IEEE P802.15
Wireless Personal Area Networks

Project	IEEE P802.15 Working Group for Wireless Personal Area Networks (WPANs)	
Title	TG3 Draft D08 to D09 changes	
Date Submitted	[1 December, 2001]	
Source	[James P. K. Gilb] [Mobilian] [12707 High Bluff Dr., Suite 335, San Diego, CA 92130]	Voice: [858-436-2201] Fax: [858-436-2301] E-mail: [gilb@ieee.org]
Re:	[]	
Abstract	[This document contains the additions made by the TG3 technical editor to the draft standard D08 to produce D09.]	
Purpose	[To provide a record of the changes to the TG3 draft standard D08 to make D09.]	
Notice	This document has been prepared to assist the IEEE P802.15. It is offered as a basis for discussion and is not binding on the contributing individual(s) or organization(s). The material in this document is subject to change in form and content after further study. The contributor(s) reserve(s) the right to add, amend or withdraw material contained herein.	
Release	The contributor acknowledges and accepts that this contribution becomes the property of IEEE and may be made publicly available by P802.15.

1. Changes from "Austin Draft Ammendements," document 01/496r2

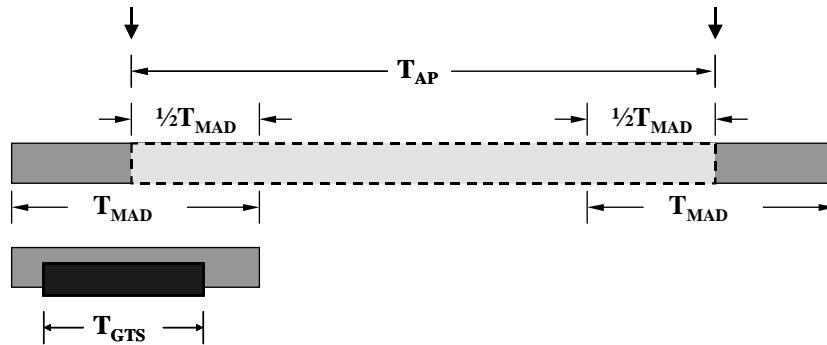
Desired GTS time, i.e. GTS time per allocation period 46

- a) T_{DMG} defines the maximum amount of GTS time per allocation period that a DEV is capable of using. $T_{DMG} > T_{GTS}$ 48
49
- b) If there is unused bandwidth, the extra channel bandwidth can be divided up among DEVs based on what they can actually use. 50
51
- c) Allows channel utilization to be maximized. 52

Ed. action: Change the CTRB to match the figure. The new figure and new text are below:

Figure 13—Illustration of the position of T_{MAD} within T_{AP}

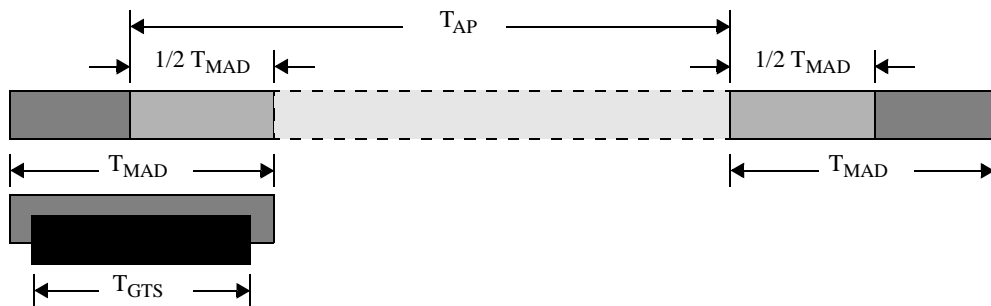
The maximum allocation delay starts before the end of the allocation period, but does not affect the PNC's reference timing of the T_{AP} period. This allows some variability in position of the GTS(s). The DEV determines this time based on the jitter requirements of the data stream that it needs to send. Figure ?? illustrates the position of T_{MAD} within T_{AP} . The T_{GTS} time is the total amount of slot time that needs to be allocated with in the T_{MAD} time centered around the start of the T_{AP} interval.

Figure 14—Possible GTS allocations that meet T_{MAD} requirements

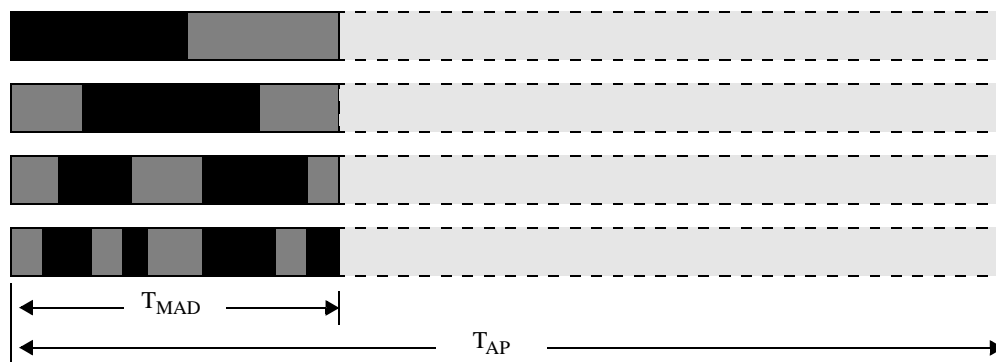
Based on the requirements for T_{MAD} within T_{AP} , the PNC has many possible ways to allocate the GTSs required by the DEV, as illustrated in .

Figure 19—Superframe structure

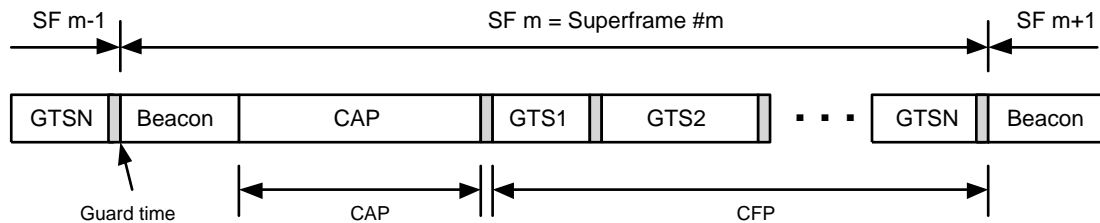
Issue 334, ADH: Figure 49 Superframe structure does not include guardtime

Suggestion: Please add Guardtimes between GTSs in diagram.

Resolution: Update figure.

Ed. action: New figure added,

Ed. action: New figure added to D09, shown below:
